THE PROPOSED WAIKATO DISTRICT PLAN

IN THE MATTER OF hearing submissions and further submissions on Variation 3

STATEMENT OF REBUTTAL EVIDENCE OF MARK SEYMOUR MANNERS TOLLEMACHE ON BEHALF OF HAVELOCK VILLAGE LIMITED [Submitter 105] FOR SUBSTANTIVE HEARING

Precinct and Zone Map

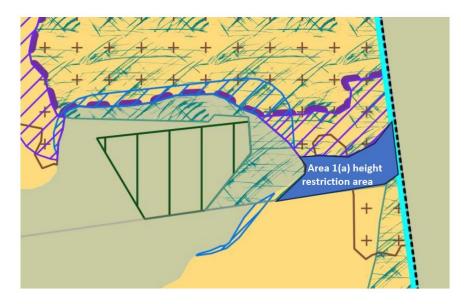
Amend to apply a new 'Height Restriction Area' to the area identified as 'Area 1(a)' below.

Delete the EPA from the extent of Area 1 identified in red below.
